PROOF OF EVIDENCE

**BARRY SELLERS MA (UD), BA (HONS ARCH), BA (HONS) TP, DIP UD, MRTPI,
IHBC, RECOGNISED PRACTITIONER URBAN DESIGN**

Site: 23-27 Arlington Works, Arlington Road Twickenham TW1 2BB

PINS Ref: APP/L5810/W/20/3249153

Fig. 5 View between nos. 6 & 8 Heathcote Road showing two storey BTM

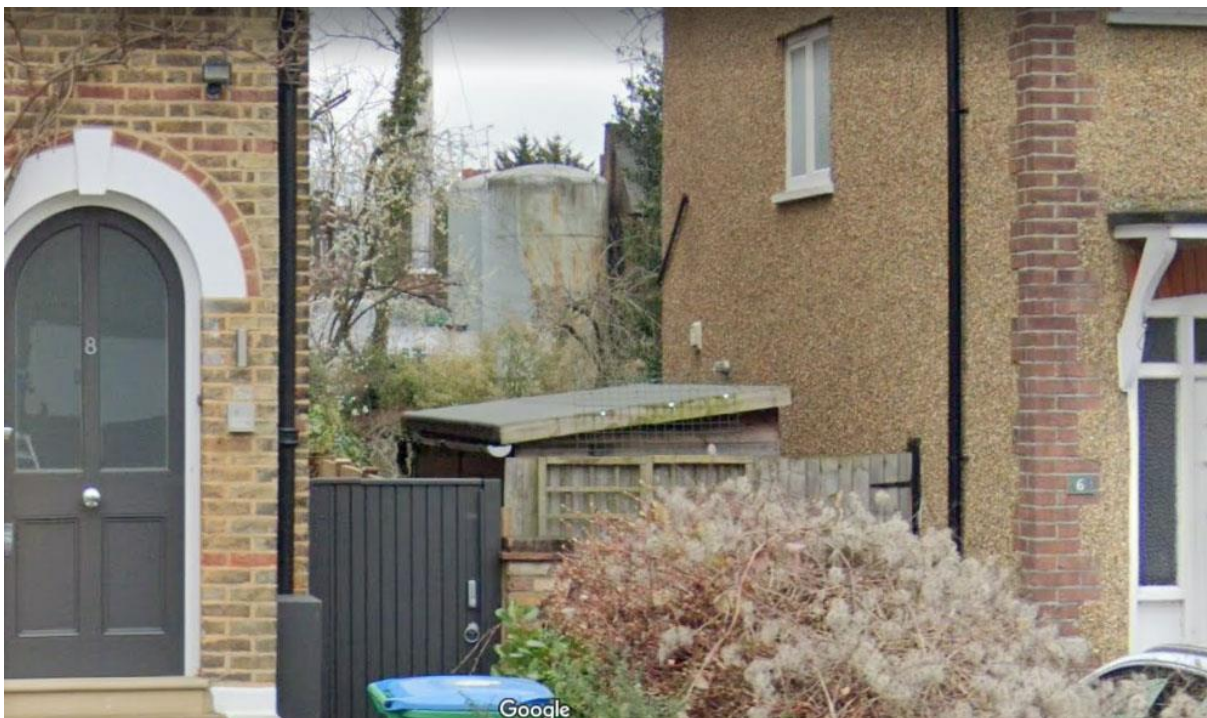
5.33 Whilst the residential properties to the west of the site over the railway in Heathcote Road are over 20 m distant in terms of habitable rooms the outlook from the rear gardens of nos. 2-12 would be adversely changed as a result of the proximity of the proposed four storey residential building (fig. 5), which would appear excessively imposing, intrusive, overbearing and over dominant. Elsewhere across the railway the residential properties are considerably further away and generally lower in height and smaller in scale. However, the proposed four storey block would loom over their rear gardens having an adverse impact on their enjoyment particularly in terms of outlook.

Fig. 6: View north from St Margaret's Road bridge

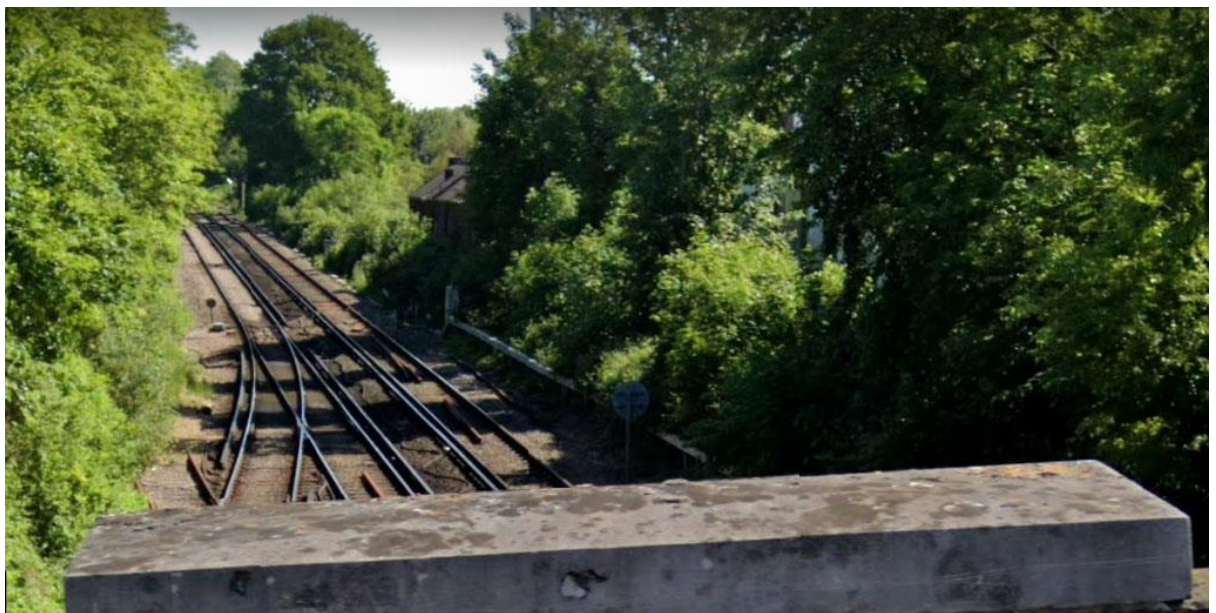
5.35 The case officer is correct to highlight this view. The townscape view from St. Margaret's Road railway bridge northwards is characterised by a well treed landscape uninterrupted by buildings (see fig 6).

5.36 This is a key view enjoyed by people going to and from the railway station. In the view the roof of one of the two storey BTMs (stable buildings) is discernible. However, in my opinion the proposed four storey building would become a visually dominant feature in this landscape, and one which would be detrimental to this cherished view. The planting visible just beyond the BTMs is mainly small shrubs which are lineside, and these would not screen the proposed four storey main building which would be visible above the BTMs. There is no analysis of this view by the appellants and no CGI to understand the potential impact of the proposed development.

8.6 I consider the view from St. Margaret's Road Bridge referred to in the Case Officer's report and suggest that the proposed development would be visible from this location. The view (fig. 6 above) is of a well-treed landscape and in my opinion the proposed development would be visually dominant in the view.
